CODE CHANGE PROPOSAL FORM

Model Code: 2024 IBC

Topic of proposal: 202, 1210.3, 2902.1, 2901.2 MAC 1109.2 + 1109.2.2

Gender Segregated Restrooms

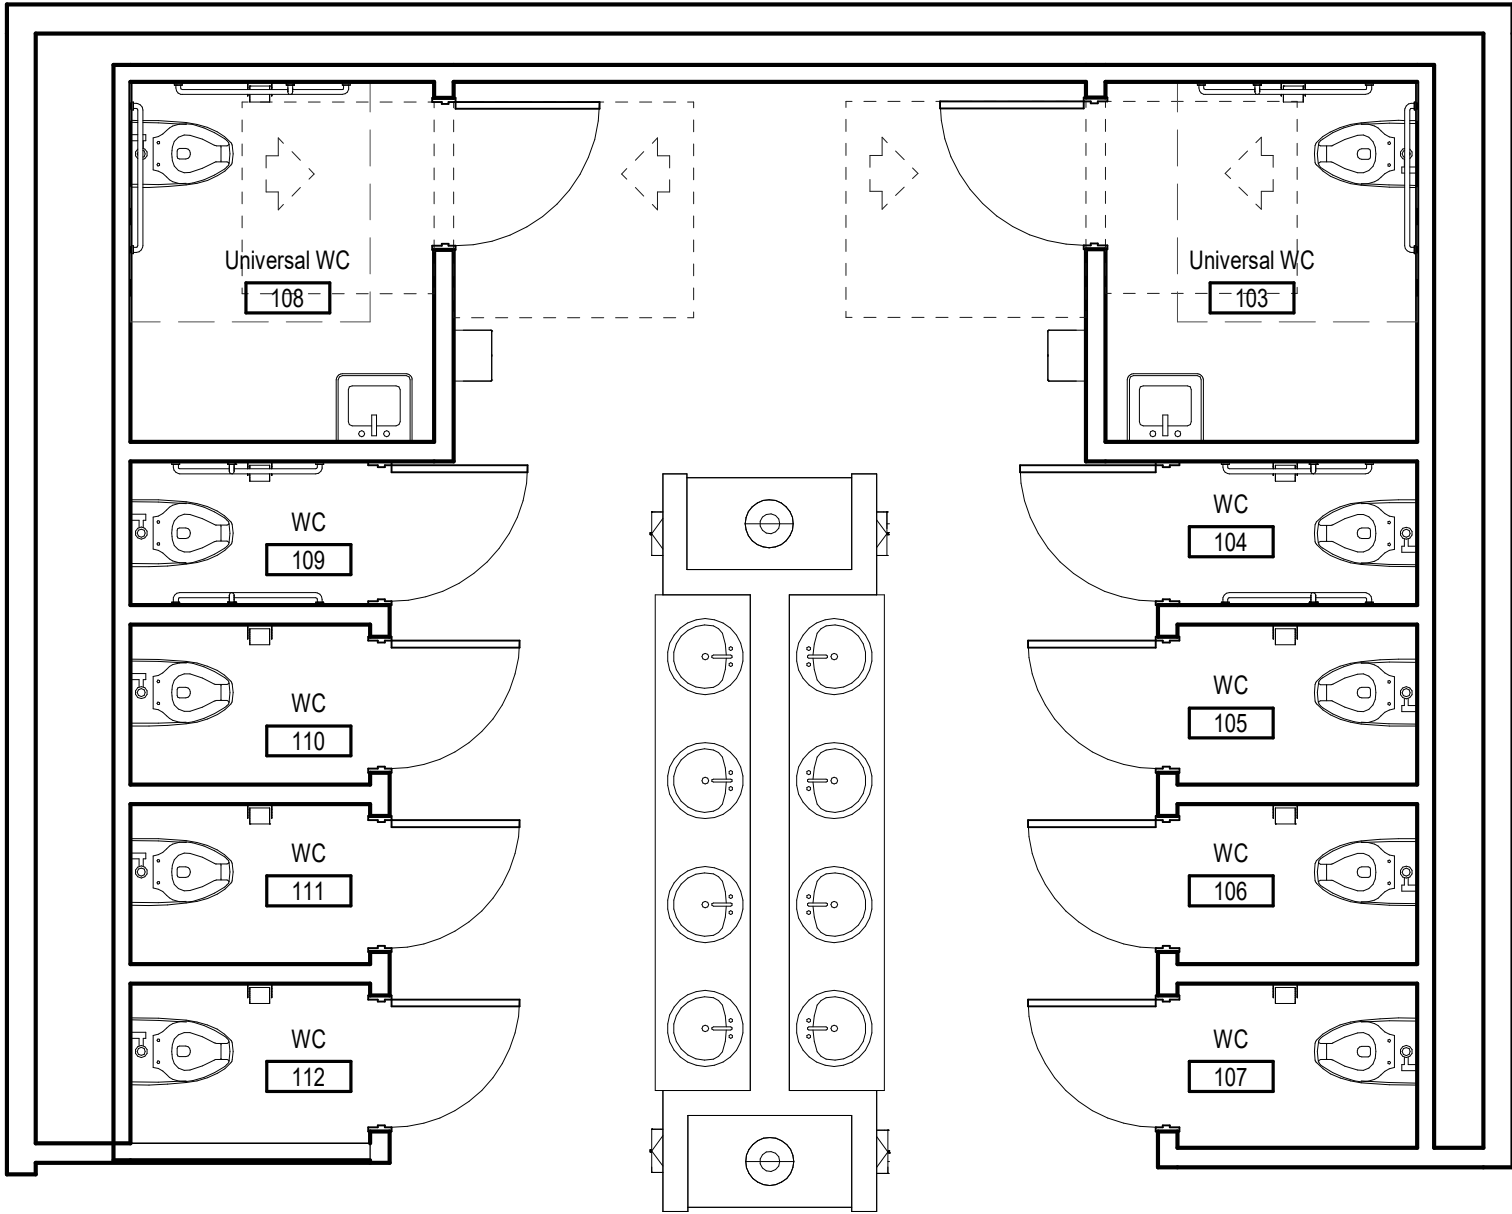
Each gender has access to 1 ADA compartment and 0 private sinks.

Each gender has access to 2 ADA compartments and 2 private sinks. Per student access to ADA compartments and private lavatories are increased in Multi-user toilet facilities not separated by sex - refer to comparison chart.
